Register Reference: SDZ22A/0014 AI

**Location:** In the townland of Aderrig, Adamstown, Lucan, Co. Dublin

**Applicant:** Quintain Developments Ireland Limited  
**App. Type:** SDZ Application  
**Planning Officer:** SARAH WATSON  
**Date Recd:** 23-Mar-2023  
**Decision Due Date:** 19-Apr-2023

## **Roads Department – Planning Report**

Figure 2.6: Minimum 6m distance to the rear of perpendicular car parking spaces, as proposed in 'Road 2 Homezone'

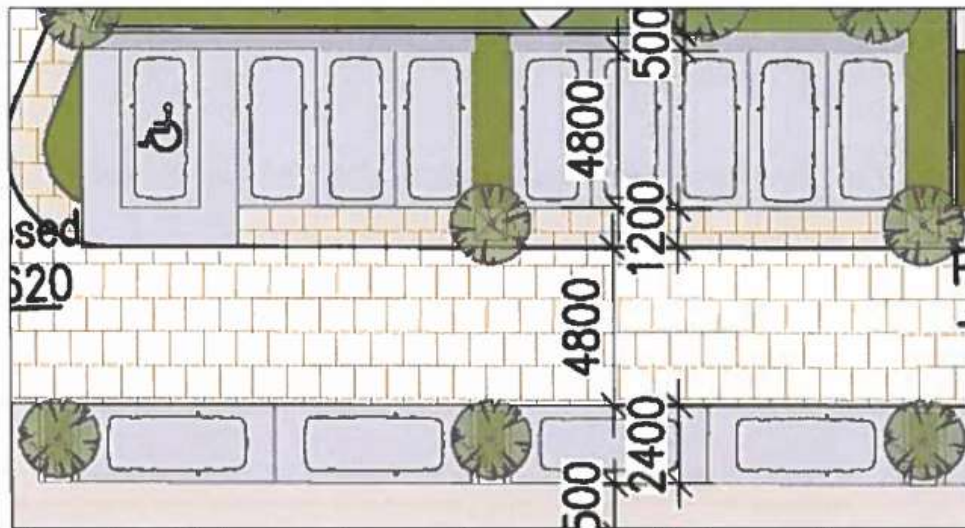
- 3.a) The applicant is requested to submit a revised layout showing perpendicular parking only being provided on one side of the street at any point. The applicant should also demonstrate a minimum distance of 6m behind each perpendicular parking space.

Roads Dept. is satisfied that there is no opposing perpendicular parking in the development area and that each perpendicular parking space has a reversing distance of 6m.

This request has been incorporated into the revised site layout – there are now no instances of opposing perpendicular car parking in the proposed development.

As is evident on BKD's site plan drawings, a minimum of 6m is achieved to the rear of perpendicular parking spaces. Please see the extracts provided in Figures 2.6–2.8 as examples below.

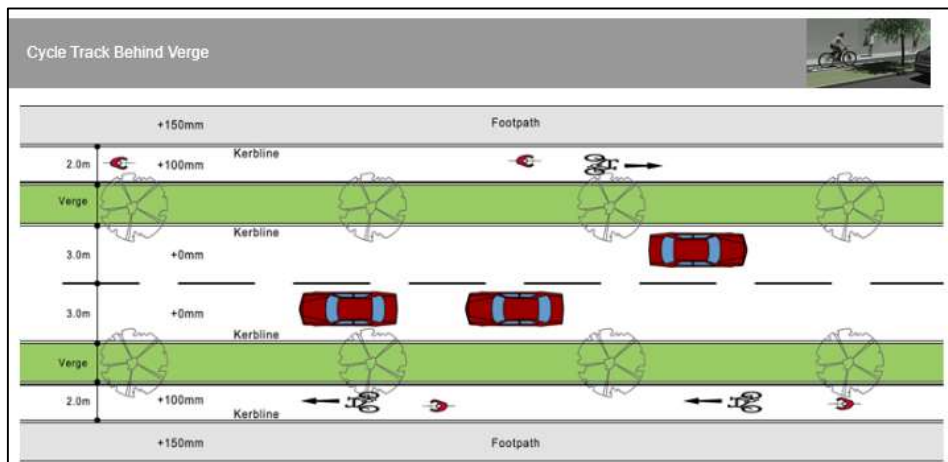
Roads Dept. is satisfied that the revised road carriageway dimensions comply with the Adamstown Street Design Guide. However, the widths of the cycle track widths along Adamstown Way and Celbridge Link Road are below the minimum standards set out in The National Cycle Manual. The submitted drawings show a cycle track widths varying between 1500mm and 1750mm. The National Cycle Manual sets a minimum width of 2000mm for a cycle track behind a verge.

1. The applicant shall submit a revised layout of not less than 1:200 scale, showing minimum cycle track widths of 2.0m as per National Cycle Manual guidelines.
2. The applicant shall submit a revised layout of not less than 1:200 scale, showing segregated footpaths and cycle tracks continued around the bus stops as opposed to a shared surface design. This layout should be designed to NTA standards.

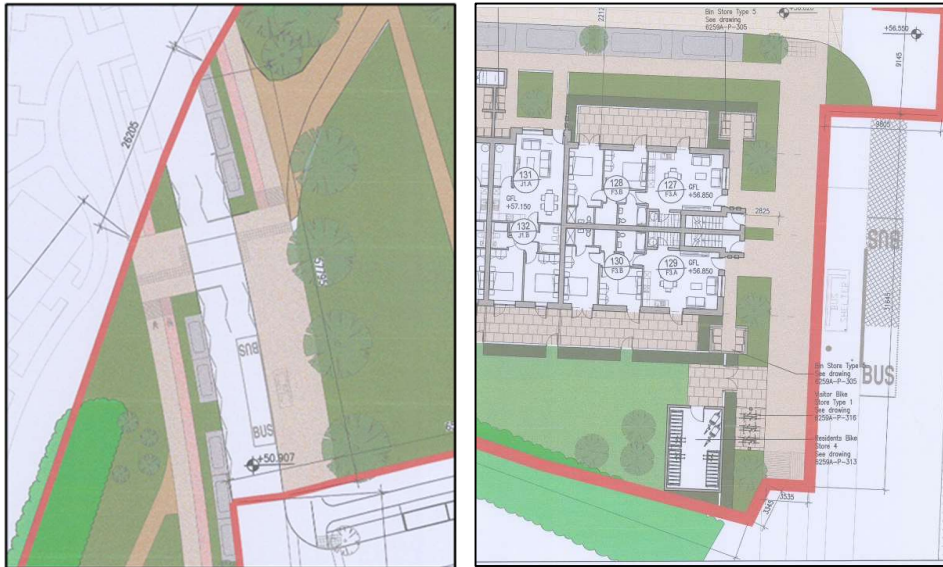
Roads Dept. is satisfied with the location of the proposed bus stops. However, the shared surface arrangements around bus stops are not designed to NTA standards. The segregated footpath and cycle track should be continued in place of a shared surface design.
